*Response to reviewer comments: egusphere-2023-1892*

Title: Evaluation of debris-flow building damage forecasts

Authors: Katherine R. Barnhart, Christopher R. Miller, Francis K. Rengers, and Jason W. Kean

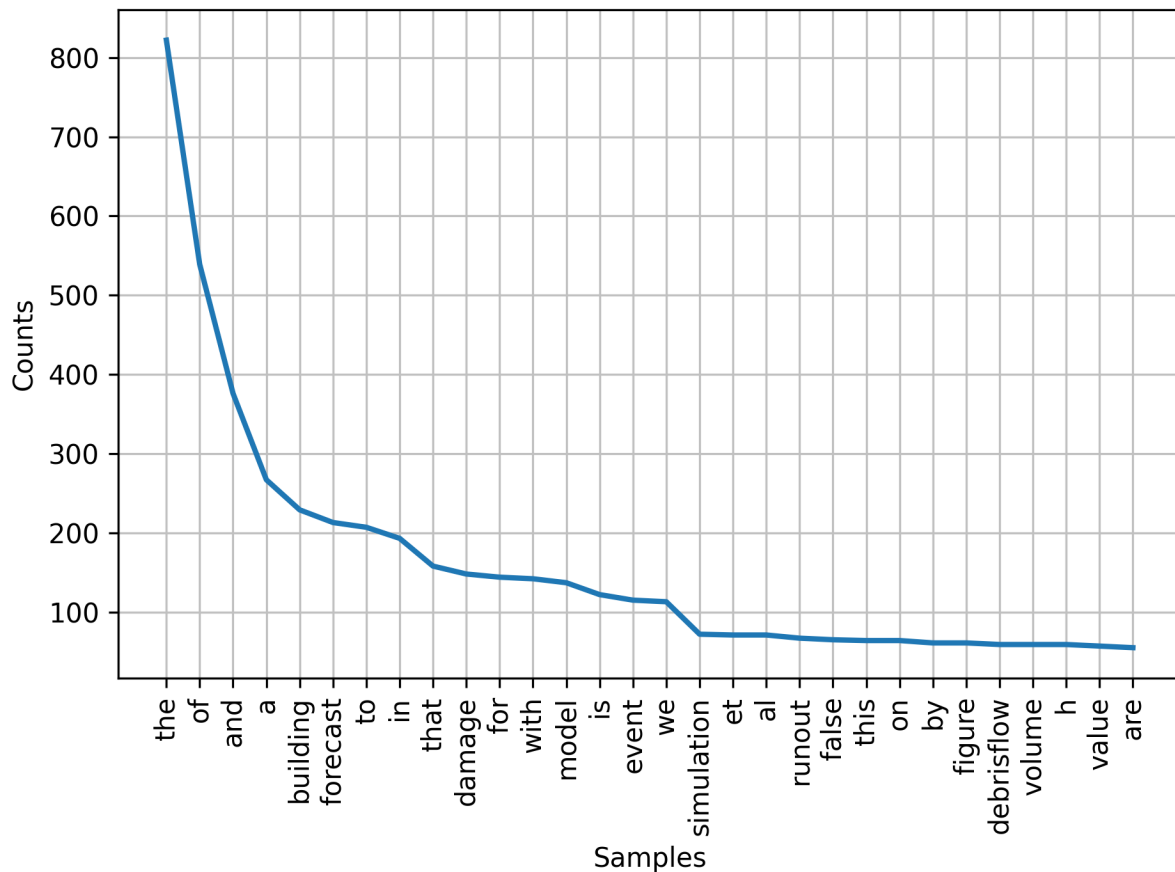
1. The redaction style of the abstract must be improved. The word "forecasts" is appearing plenty of times, to mention one of the issues. It is a key word, however, redaction can be improved with no necessity of recurring (using) to synonyms.

*In the original text, we used 'forecast' as both a noun, a verb, and an adjective. We agree that this word is used many times, but this is a consequence of the manuscript being about forecasts. We concluded that it was most important that the usage of 'forecast' as a noun remain unchanged because it is this usage where precision of language is important (we do not want to use two words to mean that same thing). Therefore, we worked through the entire document and changed all instances of the word 'forecast' used as a verb to 'predicted'. We also evaluate each use of the word 'forecast' as a noun and removed those that we determined could be removed. This still left many instances where 'forecast' is used as a noun. We elected to retain the use of 'forecast' as an adjective because in these cases we are typically discussing a product of a forecast. However, we think that not using "forecast" as a verb is a substantial improvement and appreciate that the reviewer's comment forced us to evaluate the use of language.*

To address the reviewer's general concern about overuse of words in the manuscript, we conducted a word frequency analysis to identify other words that we used many times in the text (Figure 1). We concluded that the other words we used frequently (e.g., 'building', 'damage') all have precise meaning in the context of this manuscript. Therefore, we did not make additional word choice changes.
